Item #13 Attachment G

Communications Received regarding the Meadow Way Bridge Replacement Project

Attachment 1: Marin Map showing San Anselmo creek as perennial blue line stream MarinMap Map Viewer

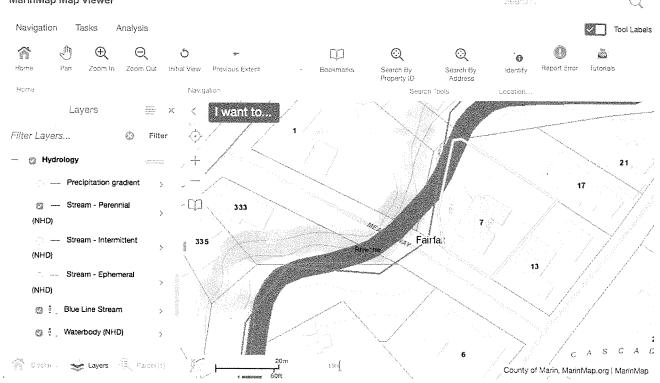
The WRA report states San Anselmo Creek is an "intermittent stream." The report has no data to support this conclusion. A couple of dry years does not validate that claim. Marin Maps, the authoritative guide on this subject, shows San Anselmo Creek as a **perennial blue-line stream**, and the creek is listed with the National Wetlands Inventory (see Attachment 1). The Marin County Watershed Program maps also shows this stream as perennial https://www.marinwatersheds.org/sites/default/files/2017-07/W_RossValley_Fish3.pdf, with anadromous fish present. This substantial error alone shows very poor research on the part of the consultant and calls into question both the accuracy and thoroughness of their entire report.

Attachment 2: Photos of Northern Spotted Owls in this reach, Cascade Canyon

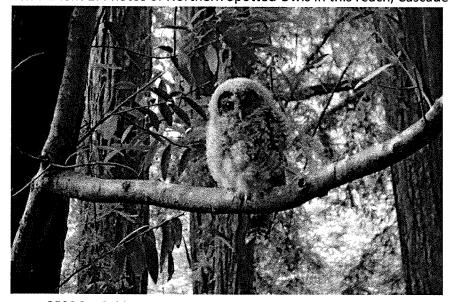
The Fairfax report and map prepared by WRA Environmental Consultants delineating Special-Status Wildlife Species says: "northern spotted owl occurrences are sensitive and not shown on this figure." This statement implies there are no NSOs that could be adversely impacted by the project. This is incorrect due to local verified observations (see Attachment 2).

Attachment 3: Steelhead Salmonid Pictures taken from San Anselmo Creek, between Meadow Way & Pastori bridges, circa 2010. Steelhead fry (juveniles) are annually seen in this stretch.

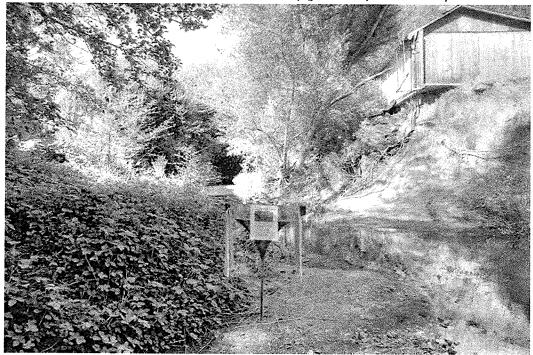
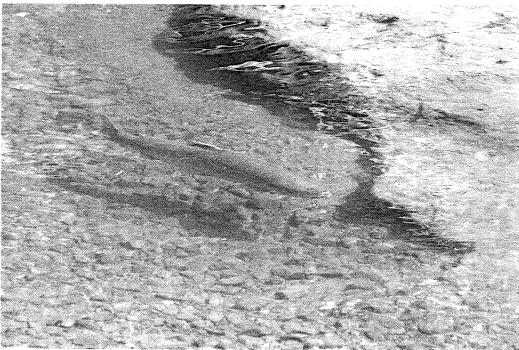
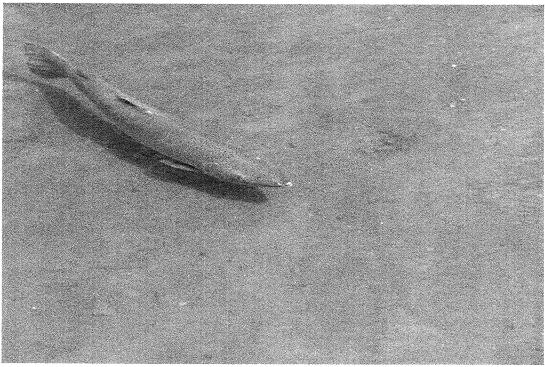
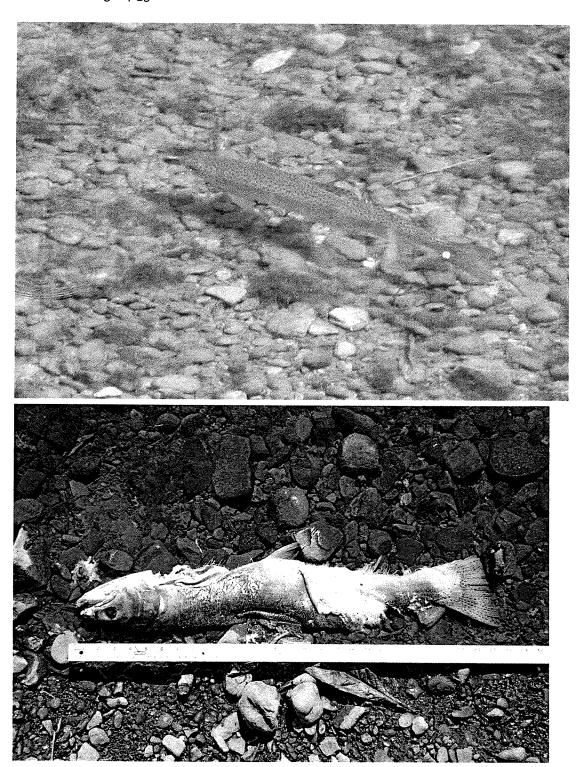
We have attached photos of spawning salmonids in San Anselmo Creek in Fairfax from 2008 that indicate steelhead presence and potentially coho (Attachment 3).
